Title **Hydraulic Modelling Addendum**

Job Name Peartree Hill Solar Farm

1 INTRODUCTION

1.1.1 This Technical Note discusses additional work carried out to support proposed Solar PV development at Peartree Hill following the Environment Agency (EA) review of the development proposals and hydraulic modelling. It forms an addendum to the Peartree Hill Solar Farm Hydraulic Modelling Report 20-206-60-050.

Figure 1-1 CFMP catchment sub-areas

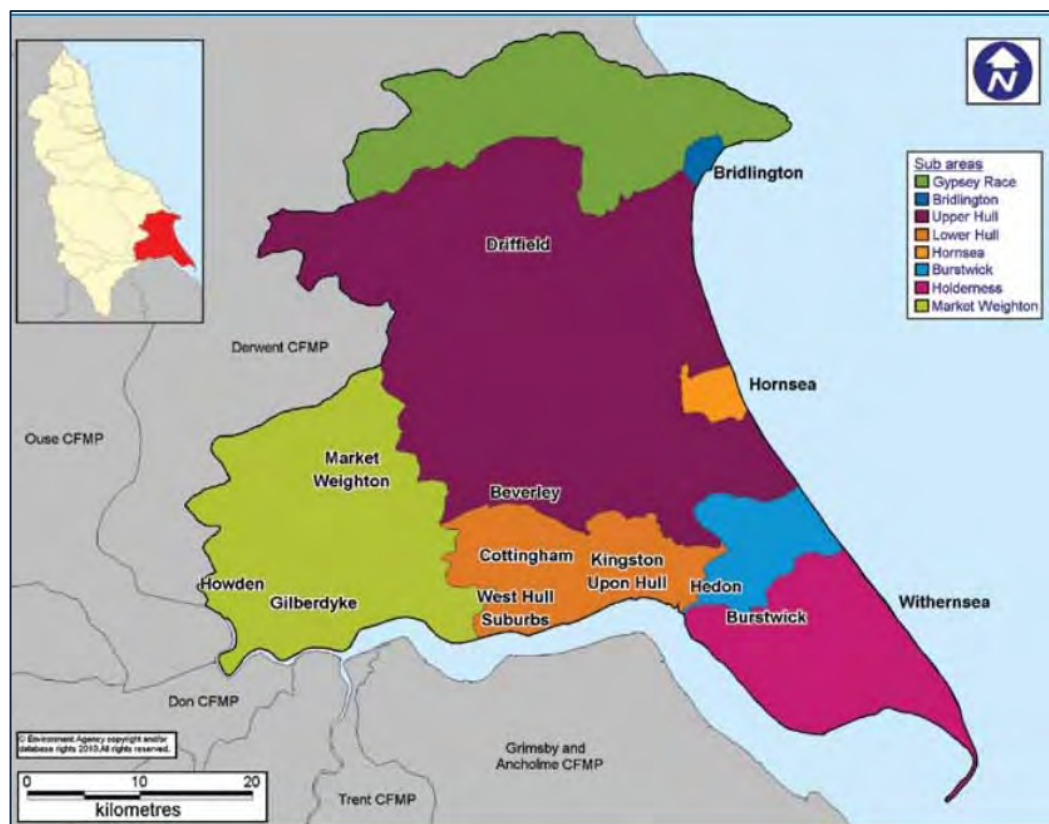
"Although breach modelling is being undertaken by the applicant, any assessment of residual flood risk, both now and in the future, will be insufficient without further consideration of the condition of the flood defences. Through understanding the condition of existing defences and how defence conditions may change over the lifetime of the development, you must give appropriate consideration to how residual flood risk can be managed and mitigated."

- 2.2.1 The site benefits from a range of defences. The policy for managing flood risk in this area is set out in the Hull and Coastal Streams Catchment Flood Management Plan (CFMP). The document which was published in 2010 sets out “our preferred plan for sustainable flood risk management over the next 50 to 100 years”.

- 2.2.2 There have recently been significant defence improvements in the area generally consisting of flood embankments and walls which have been designed so a managed adaptive approach can be taken – i.e. so that the height of these defences can be raised in the future to keep pace with sea-level rise should it be required.
- 2.2.3 Give the commitment to defences in this area, the fact that they protect thousands of properties in the City of Hull and that tidal flooding would be significantly attenuated before reaching the site no further investigation is considered necessary, as agreed with the Environment Agency during a meeting on 1st July 2024.

Figure 3-1 Missing Structures

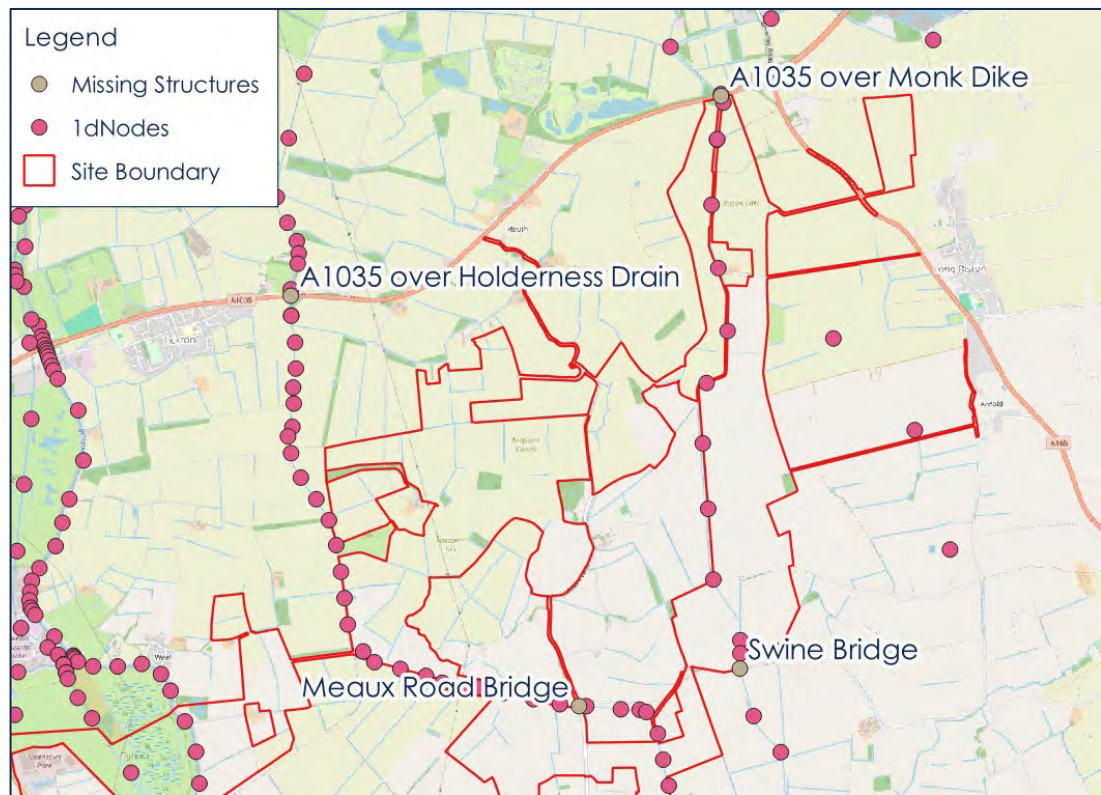
- 3.1.1 The EA model review notes a number of missing structure in vicinity of the site as listed below and shown in Figure 3-1:
- A1035 bridge over Monk Dike (FM cross section Cat00000)
 - A1035 bridge over Holderness Drain (FM cross section HN43),
 - Swine Road Bridge over Monk Dike (closest FM cross section MK4055), and
 - Meaux Road Bridge over Holderness Drain (FM cross section HN21).

- 3.1.2 Three of these structures have been added to the model using available data and where information was sparse a conservative approach to the structure definition was taken. The structure at HN21 as it appears to be a clear span structure with the deck approximately 3m above the maximum water level. Structure details definitions are appended to this document.

- 3.1.3 The model was reran with the design event flood. The maximum flood level was compared with the existing baseline design event outputs and the results are shown in Drawing 20-206-60-255-00 & 20-206-60-256-00.

- 3.1.4 Flood levels are generally within +/-20mm within the site boundary, the exception being a small part of parcel B1 where levels are reduced by 60mm and land west of parcel F12 where levels are reduced by 180mm. The only significant increase within the site are the parcels to the east of the Monk Dike (B2-4, B8 & C1-C3) where levels increase by 20mm. The change in outline is insignificant.

- 3.1.5 Given the very minor changes experienced in flood levels across the site it is concluded that the definition of these structures has no material impact on the flood levels, the mitigation (a freeboard of 300mm has been applied), or the layout.

Figure 4-1 Gauge Locations.

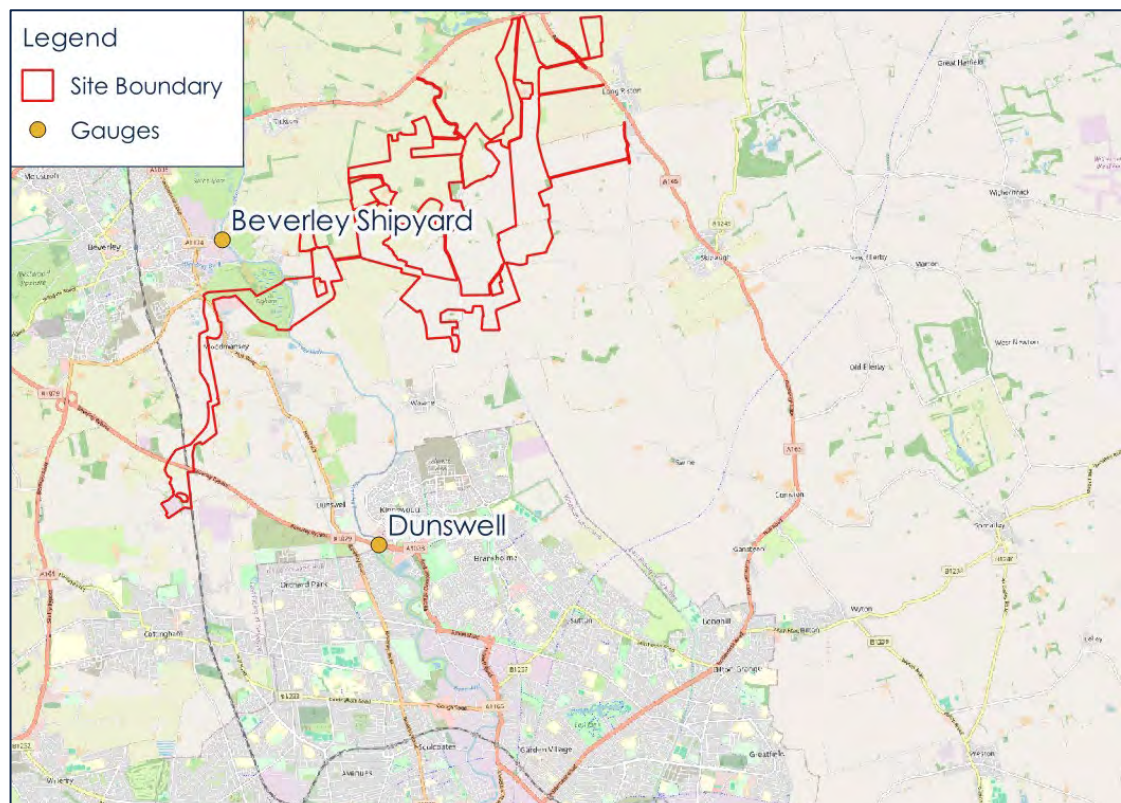
The EA model review spreadsheet includes peak water levels for most years for two gauges: Dunswell gauge starting from 2001 and the Beverley Shipyard gauge starting from 1994. The location of the gauges is shown in Figure 4-1.

5.1.1 Both of these gauges are located on the River Hull which is heavily tidally influenced and drains a large catchment so the causes of high levels are difficult to apportion. This is complicated by the fact the tidal ingress and fluvial egress are prevented when the Hull Tidal Surge barrier is closed.

- 5.1.2 The levels at Beverly Shipyard which are most relevant for the site vary between 2.99mAOD and 3.89mAOD over the 29 year record and have an average value of 3.54mAOD. When accounting for the predicted sea level rise to 2066 of 0.36m, the peak modelled flood level of 4.06mAOD seems reasonable.
- 5.1.3 The tidal boundary has been subject to sensitivity testing as have the fluvial flows neither of which produce significantly different results.
